From: Hobenshield, Lexa [Lexa_Hobenshield@kindermorgan.com]
Sent: Wednesday, February 8, 2012 10:23 AM
To: 'S22 Van Velzen, Wayne ENV:EX
Cc: S22 S22 ; 'John.Wilmshurst@pc.gc.ca'; Droppo, Mike; Back, Scott ENV:EX; Zimmerman, Ted FLNR:EX; 'terry@salmoconsult.com'; 'amsyslak@cpaws.org'; 'Thea.Mitchell@pc.gc.ca'; 'georgesmith@dccnet.com'; Goetz, Peter ENV:EX
Subject: Re: Agenda for Feb 1 TMLF meeting

**RE: Kinder Morgan Canada Inc., TMX - Anchor Loop Pipeline Project
Erosion and Sediment Control Plan to be Implemented at Seven Disturbances Located at
Five Sites (KL 419.5, KL 419.7, KL 424.65, KL 424.95 and KL 425.95) Adjacent to the CN and
TMX – Anchor Loop Rights-of-way in Mount Robson Provincial Park, British Columbia**

RE: **Trans Mountain Pipeline L.P. TMX - Anchor Loop Project**
Compensation Effectiveness Monitoring: 2011

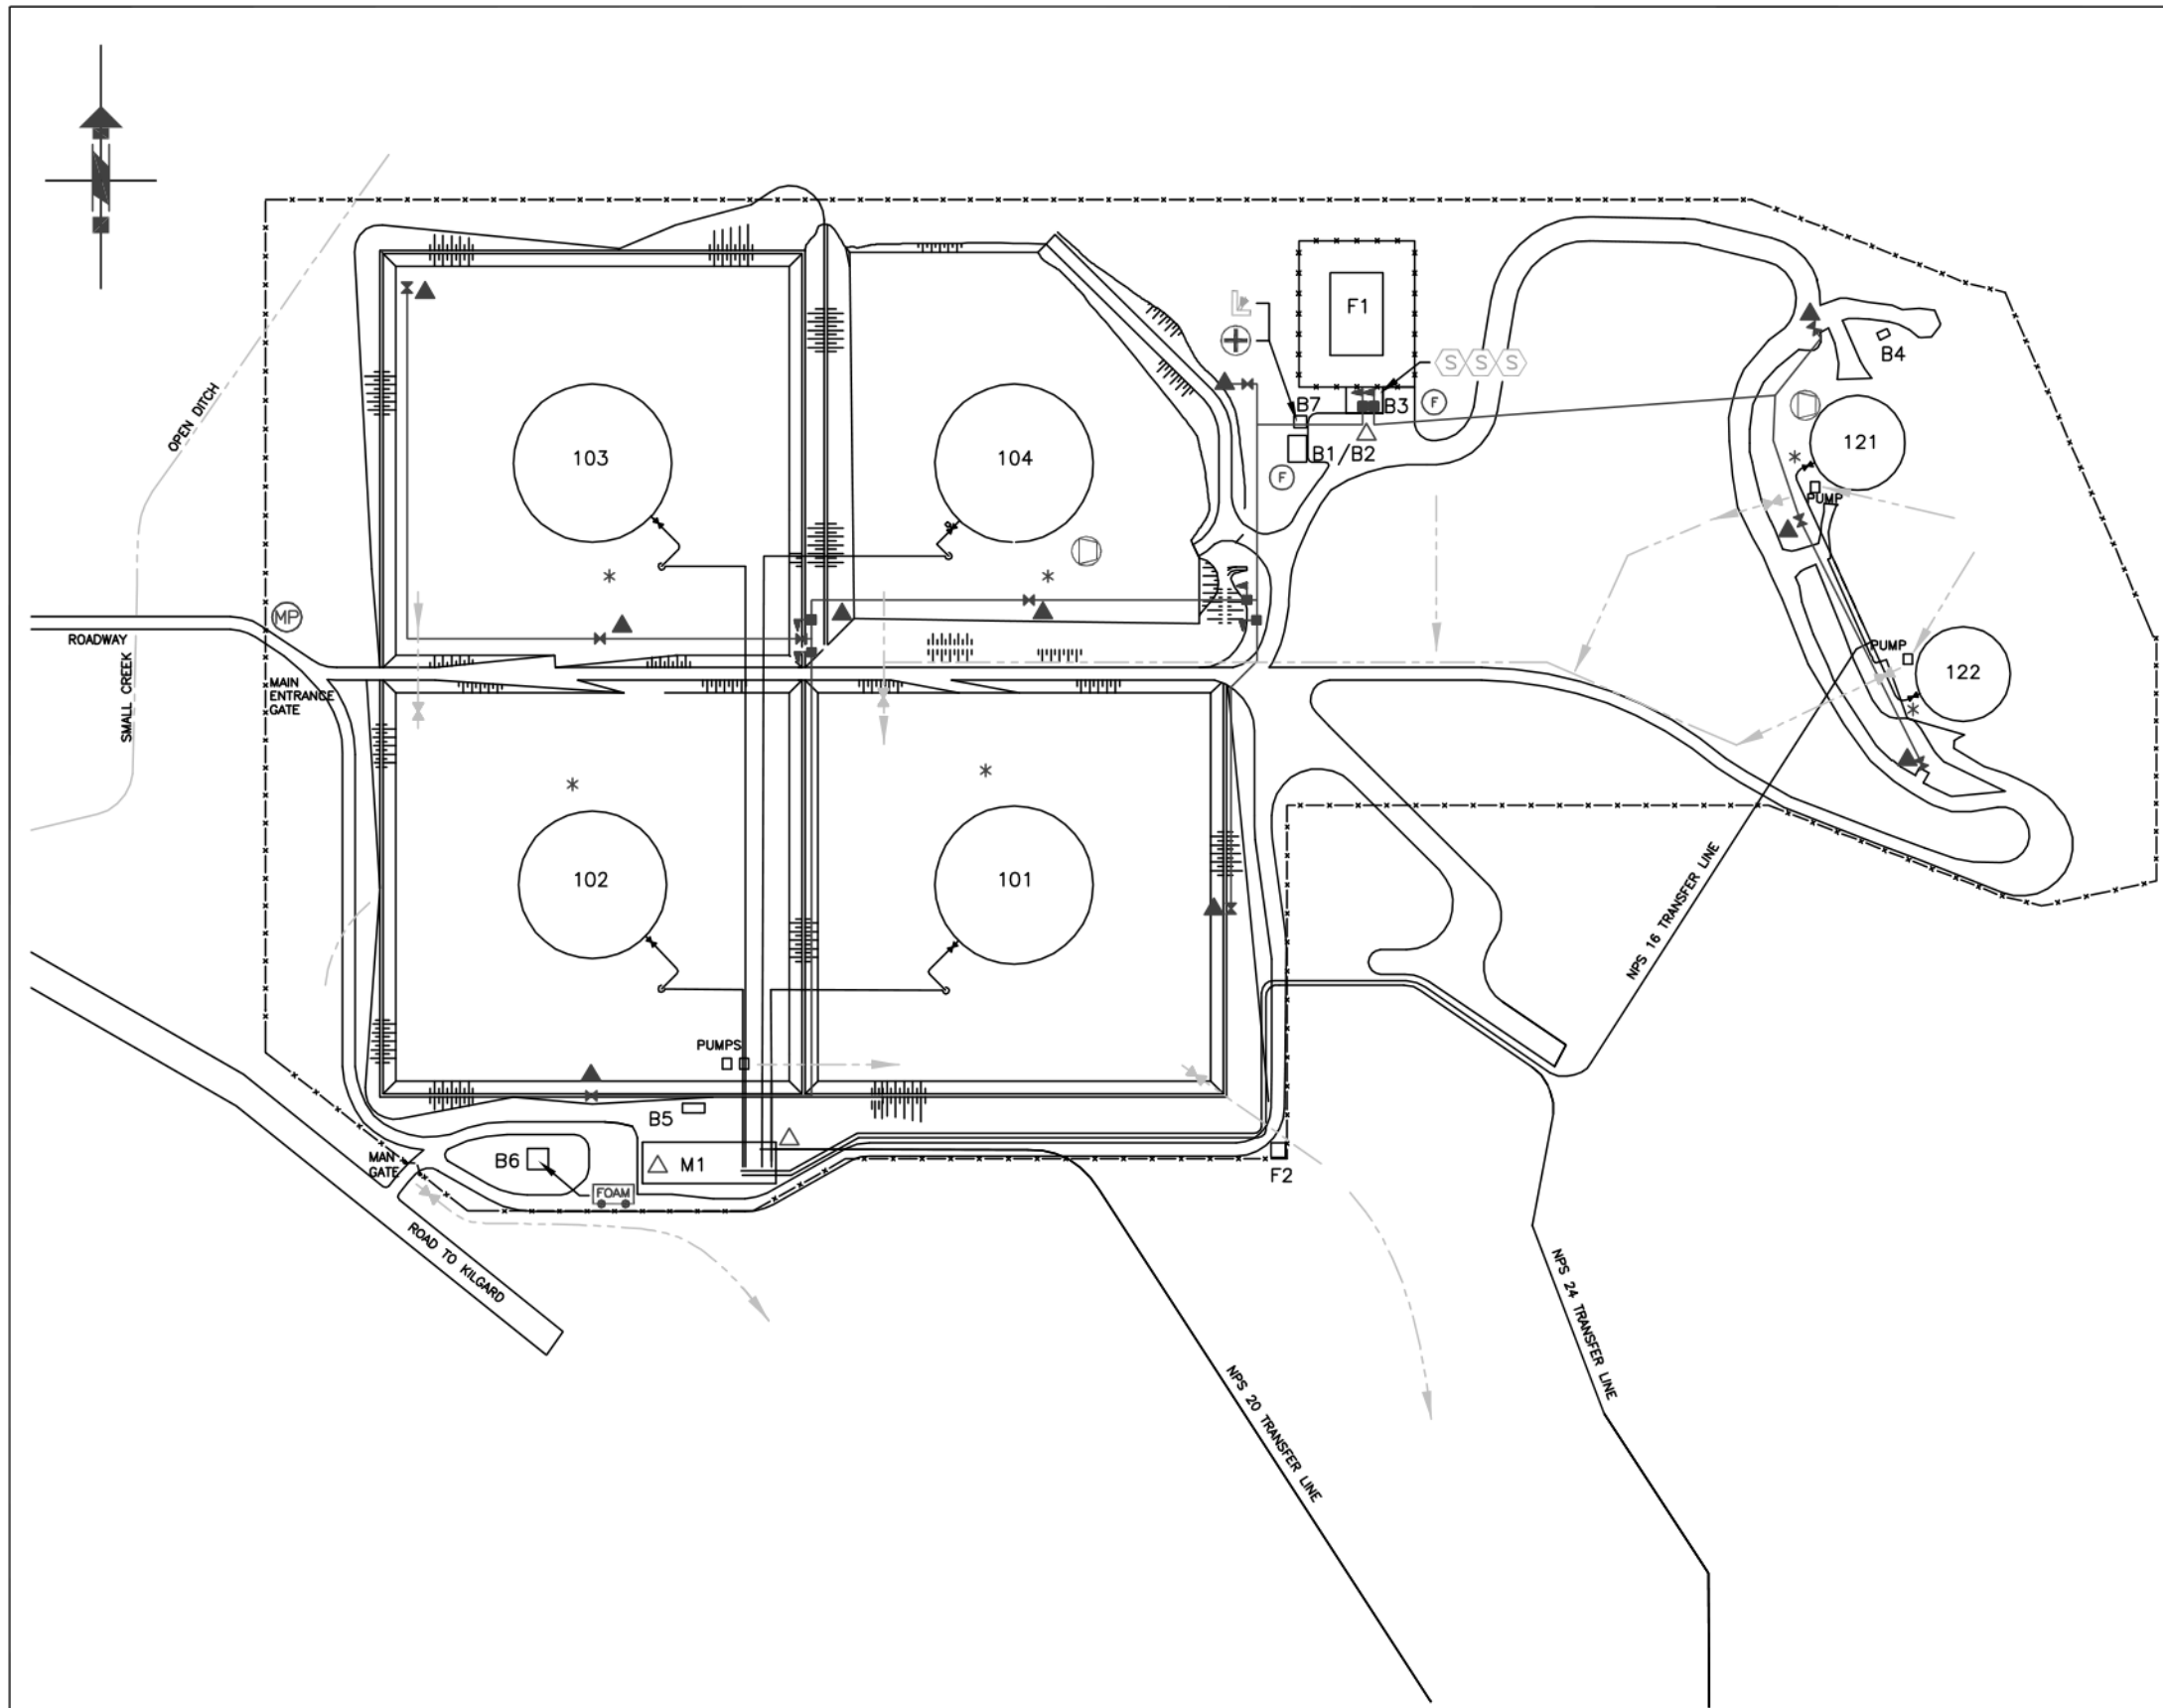
32	January 26, 2012			Drinking Water: The document indicates that risks to drinking water supply wells will be evaluated by Golder Associates. Nearby wells will be identified and risk to each well will be evaluated. Follow-up action will be taken for any wells identified to be at risk. Further information regarding the drinking water assessment is anticipated.	Noted
33	January 26, 2012			<p>Air Monitoring Plan: KMC prepared the Ambient Air Monitoring Plan (AAMP) to address and document methods and procedures for sampling ambient air adjacent to and in neighbouring residential areas in response to the crude oil release. Air quality will be monitored at a number of locations for benzene, total VOCs (LEL), and H2S. KMC indicates that the data will be collected for health and safety purposes.</p> <p>Note that the CSR provides generic numerical vapour standards (see Schedule 11 of the CSR). With respect to the CSR, vapour contamination exists if the concentration of any vapour PCOC that is associated with a soil, sediment or water source exceeds its Schedule 11 standard in the breathing zone. Assessment of vapour concentrations in the vicinity of the spill is recommended. Further investigation and remediation may be required should vapour contamination be identified. Vapour contamination originating onsite and migrating offsite must be fully delineated.</p>	The release was contained within the Tank 121 bay. If impacts are noted outside the synthetic liner, a review of the requirement for additional site assessment will be conducted.

34	January 26, 2012			Soil Sampling Plan: KMC indicates that soil sampling may not be possible as the spill was contained within the tank berm; therefore, KMC proposes to collect swab samples of the liner along the base and sidewalls of the tank berm. Samples will be analyzed for EPH and BTEX. Should affected areas of soil be observed, representative soil samples will be collected and submitted for analysis of EPH and BTEX. Although soil confirmatory samples are preferable to swab samples from the liner, groundwater and surface water monitoring can provide confirmation that unacceptable impacts did not occur.	Noted

#	Date of Comment	Role		Comment	Reply
35	January 26, 2012			Surface Water Monitoring Plan: Upstream Control Site (0.5 km upstream, located inside TK101 berm); Source at discharge from tank farm South East corner; Downstream of site (0.5 km downstream). KMC proposes to analyze samples for TEH, Daphnia and LC50 (100%). Note that TEH is not a CSR-regulated parameter. Please determine appropriate potential contaminants of concern based on the crude oil analysis.	See response to Comment #22, above.
36	January 26, 2012			It is preferable that a statement be provided, along with supporting documentation, by an approved or qualified professional that the crude oil spill has not caused impacts to site soil, surface water, groundwater, sediment or vapour at concentrations in excess of CSR standards.	On completion of the remedial program, a remediation completion report will be prepared, which will include review by an approved professional.
